Office Action Summary	Application No. 10/803,051	Applicant(s) PLANTAN, RONALD S.	
	Examiner Melody M. Burch	Art Unit 3657

DETAILED ACTION

3. Claims 1-9 are rejected under 35 U.S.C. 102(e) as being anticipated by WIPO 2004/026649 to Simmons.

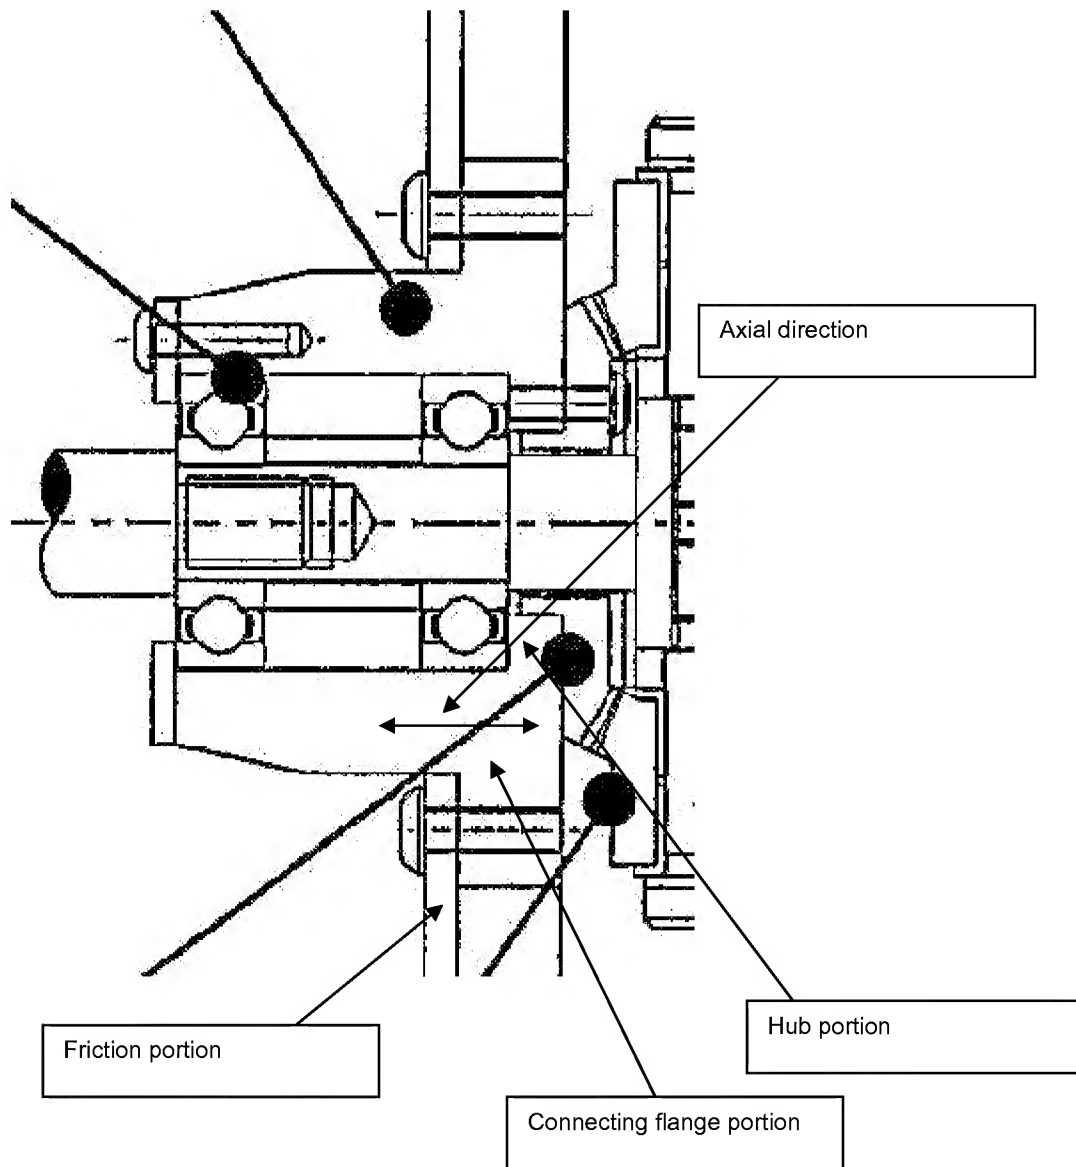
Re: claims 1-3. Simmons shows in figure 5 a brake disc 18 comprising a hub portion shown immediately to the left of the circle at the end of lead line 24, a friction portion shown in the area of the circle at the end of element number 18, the friction portion formed as a generally planar ring and a connecting flange portion shown in the

area to the right of the circle at the end of the lead line for element number 20 wherein the connecting flange portion connects a radially outer region of the hub portion to a radially inner region of the friction portion radially inward from a radially inner most friction surface of the friction portion, the connecting flange portion has a length such that when the hub portion and a wheel rim as labeled in the annotated version of figure 5 of Simmons provided in this Office action (see pg. 6) adapted to be mounted on a hub end as labeled of a vehicle axle 14 are concentrically located at the hub end of the axle, the friction portion is outboard of the wheel rim, and the friction portion has an outer radius greater than a greatest inner radius of the wheel rim as shown.

Re: claims 4-6. Simmons in figure 5 shows an at least one heat-conduction limiting section or reduced thickness shown at the bottom of the portion shown in the area of the end of the lead line of number "18".

Re: claims 7-9. Simmons shows in figure 5 at least one ventilation aperture as labeled in the annotated figure provided in this Office action.

Re: claims 17-19. Simmons, as modified, teaches in figure 5 of Simmons an at least one heat-conduction limiting section or reduced thickness shown at the bottom of the portion shown in the area of the end of the lead line of number "18".

Re: claims 20-22. Simmons, as modified, teach in figure 5 of Simmons at least one ventilation aperture as labeled in the annotated figure provided in this Office action.
